January 9, 2015  
10 CFR 50.90  
SBK-L-14225  
Docket No. 50-443

Seabrook Station  
Response to Request for Additional Information Regarding License Amendment Request 14-02  
Proposed Change to Increase Voltage Limit for Diesel Generator Load Rejection Surveillance Requirement

**Attachment 1 to SBK-L-14225**

DIESEL GENERATOR DG-1A AND DG-1B ONE LINE DIAGRAM  
SHEET 1 OF 2  
UNIT 1 1-NHY- 310010

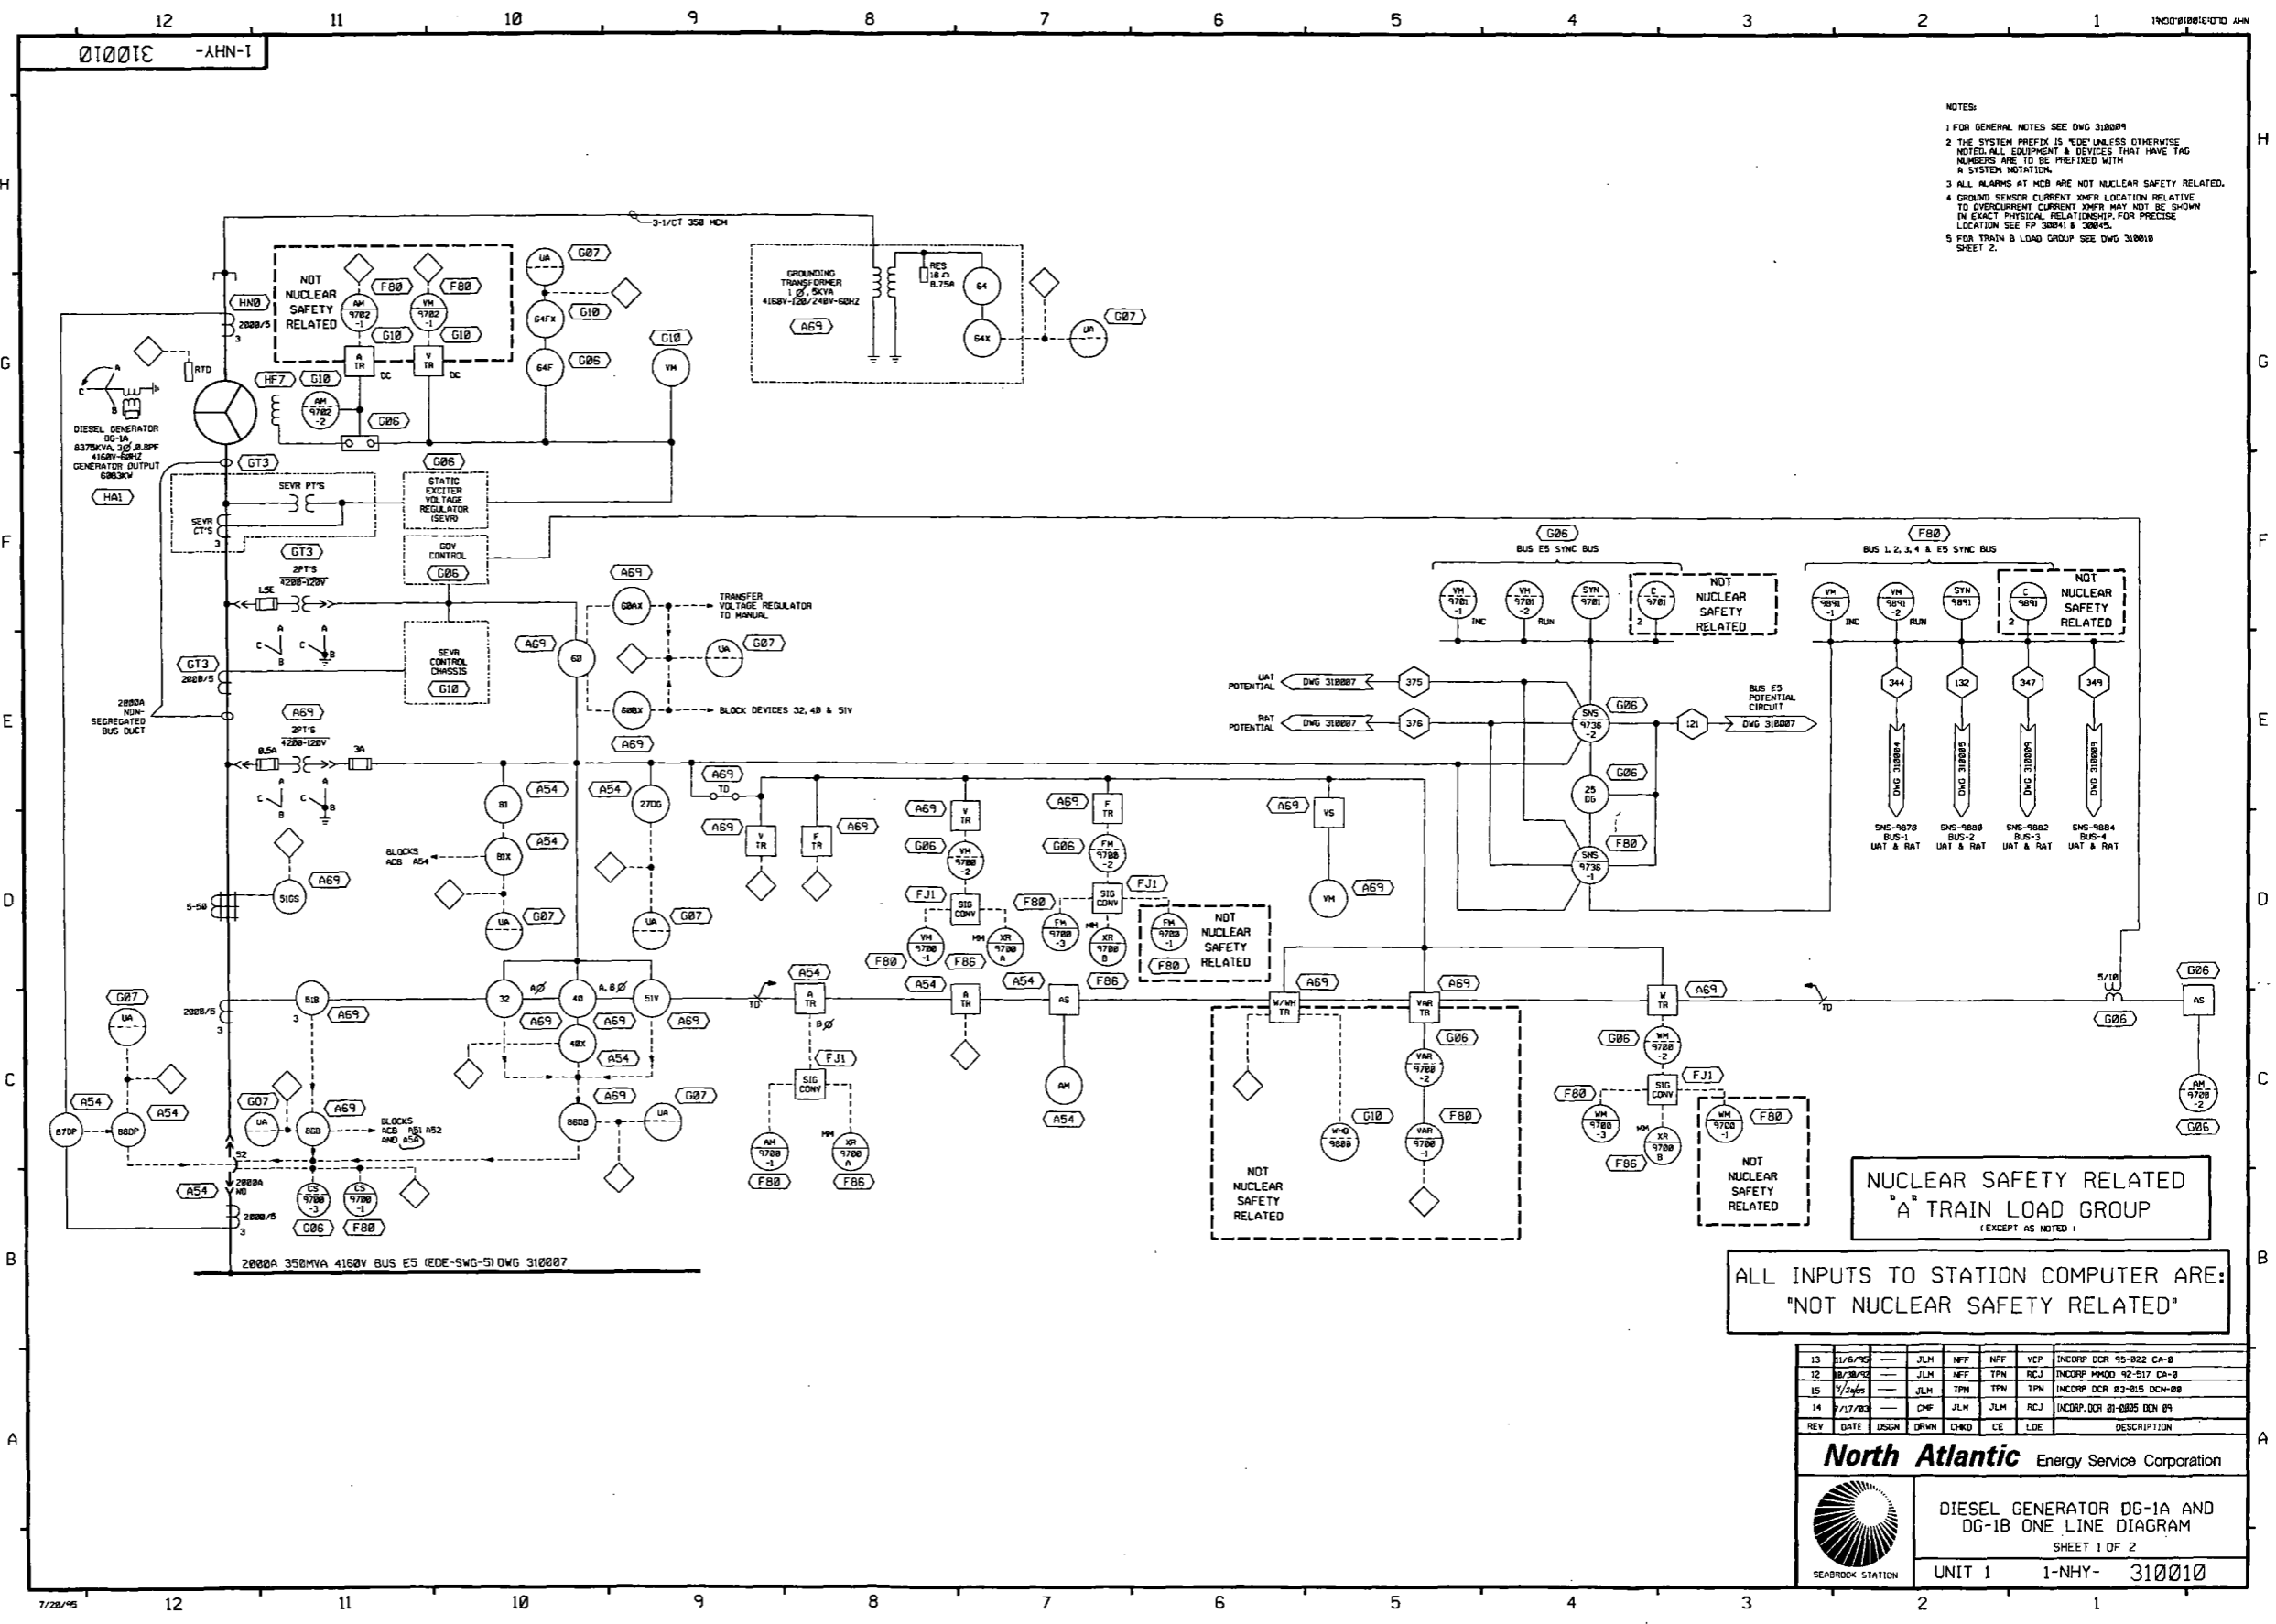
Please provide a copy of the single line diagram showing the connection of one of the EDGs to an emergency bus and associated protections (protective relays, etc.) provided for the EDG.

See Attachment 2 for drawing 1-NHY-310010, Sh. 1, Diesel Generator DG-1A and DG-1B One Line Diagram, for DG-1A protective relays.
